# CITY OF MILWAUKIE

### PLANNING COMMISSION

- 4.1 Summary: 32<sup>nd</sup> Ave Mixed-Use Building  
Applicant: Valerie Hunter  
Address: 9391 SE 32<sup>nd</sup> Ave  
File: VR-2019-013  
Staff: Vera Kolas, Senior Planner

Review application VR-2019-013, take public testimony, and consider making a tentative decision and continue the hearing to July 14 for a final decision. Please provide staff with direction to provide findings for approval or denial at the next hearing based on discussion and deliberation.

Figure 6. West facing elevation (red line indicates the 45-ft max. height allowed)

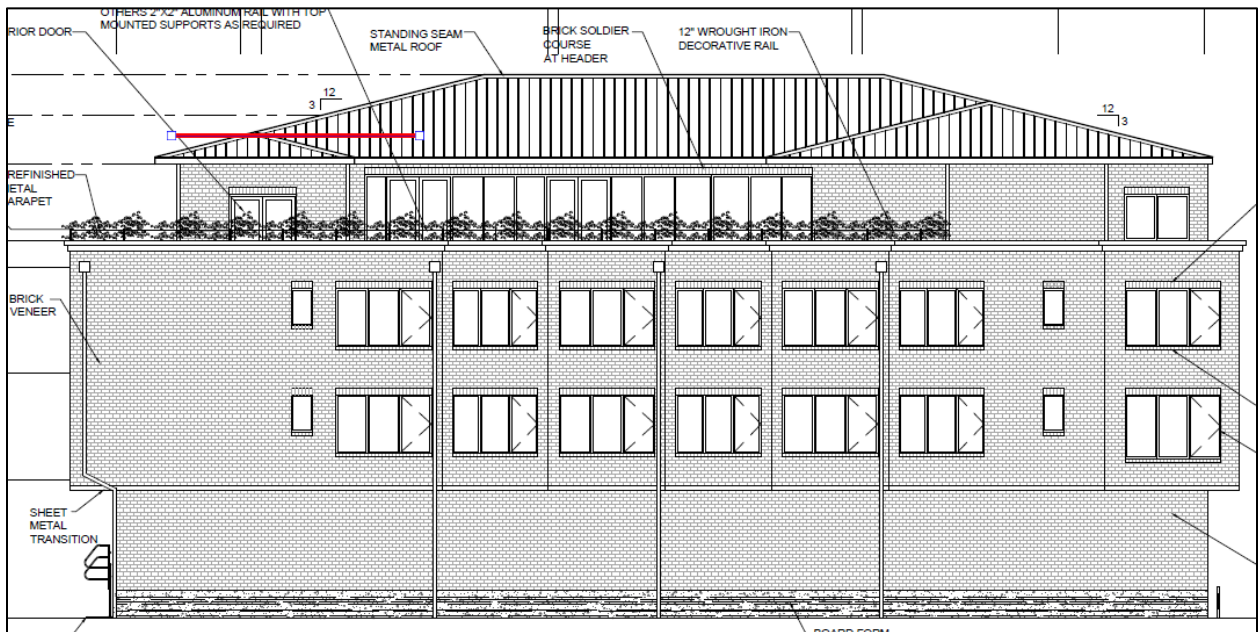
Type III Variances require the Planning Commission to find that the proposal meets the criteria set forth in MMC 19.911.4.B. The applicant has chosen to address the discretionary relief criteria which means an alternatives analysis must be prepared and the variance must be found to be reasonable and appropriate. The application materials focus on the benefits of a mixed-use building in the NMU zone and state that the project would add amenities to the neighborhood. The application does examine the benefits of the additional story, which is for the construction of a large single apartment.

But for the height variance, the proposed building meets the design and development standards for a mixed-use building in the NMU zone. Based on the purpose statement for the NMU zone, the proposal meets the intent as a mixed-use building. However, the Ardenwald NDA, and others, submitted comments regarding the size of the commercial spaces, stating that they would be too small to provide for useful “neighborhood hub” type businesses. Many comments noted appreciation for reusing a vacant site and the desire for neighborhood amenities. However, all commenters oppose the proposal as designed with four stories.

As described in the application materials, the proposal minimizes any visual impacts of the additional height to adjacent residential properties, and reduces the massing of the building at the property lines, by designing the fourth floor to set the dwelling unit back from parapet walls at the top of the third floor. In addition, the design includes a large wrap-around deck, decorative rail, parapet, and landscape planters (see Figures 6 and 7). These last few details will also act as screening, providing privacy for adjacent neighbors. As stated in the application materials, the height of the screening was determined by a line-of-sight study which was not included with the application materials.

Figure 7. North facing elevation (red line indicates the 45-ft max. height allowed)

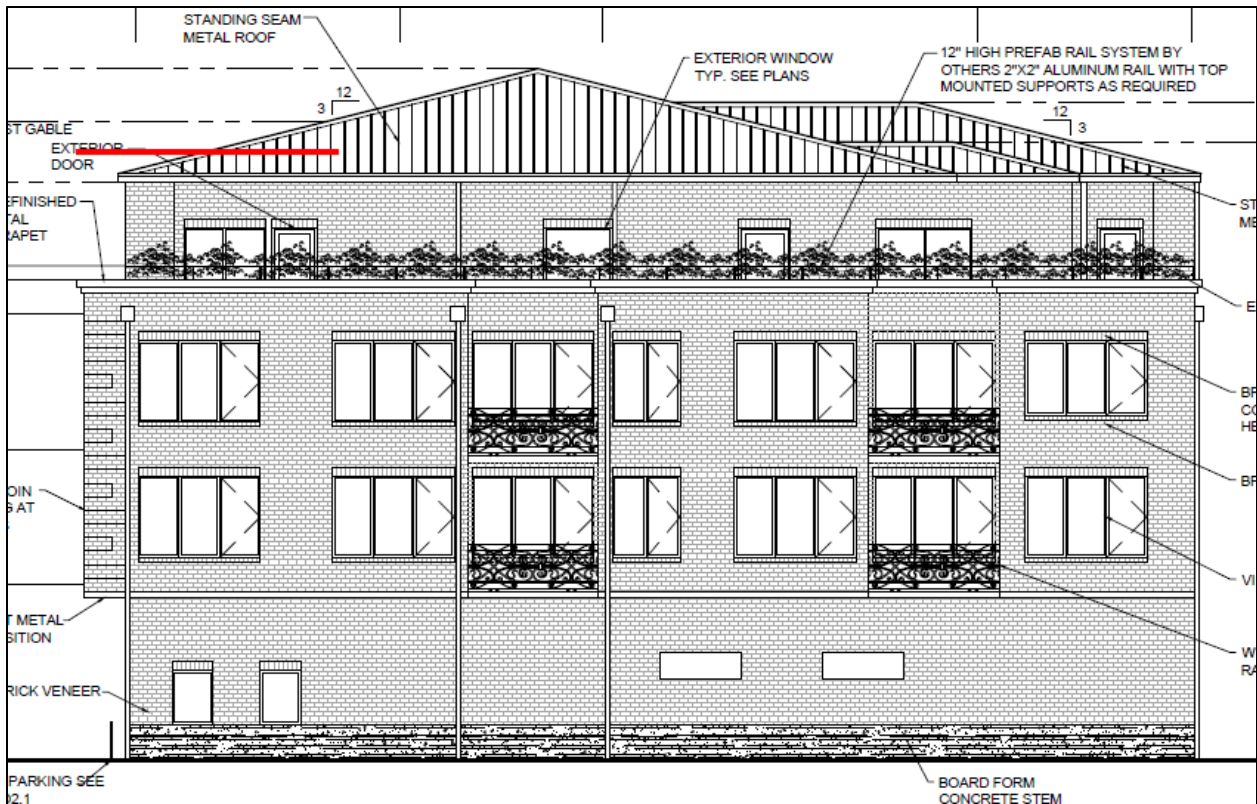
The application also states that the proposal mitigates the effect on surrounding properties as the area of increased height – the fourth floor – is set back away from neighboring properties. The predominant mass of the fourth floor will be located on the street-facing facades and away from the residential neighbors. The building has a 16-ft setback from the northern property line allowing for minimum intrusions to the northern neighbors. On the western property line, the fourth floor will be set back through the use of a patio area from the exterior wall of the floors below. The patio on the western property line varies in width between 9 and 17 ft.

Many comments were submitted expressing concern about the scale of the proposed building particularly in relation to adjacent one- and two-story residences, especially since there are no minimum setbacks. Staff notes that, unlike the General Mixed Use zone (GMU), a height bonus is not available in the NMU. This decision was made during the NMU code amendment process and reflects the neighborhood-scale development that was intended for this area. The question, then, is what does the proposal provide that responds to these concerns? While the
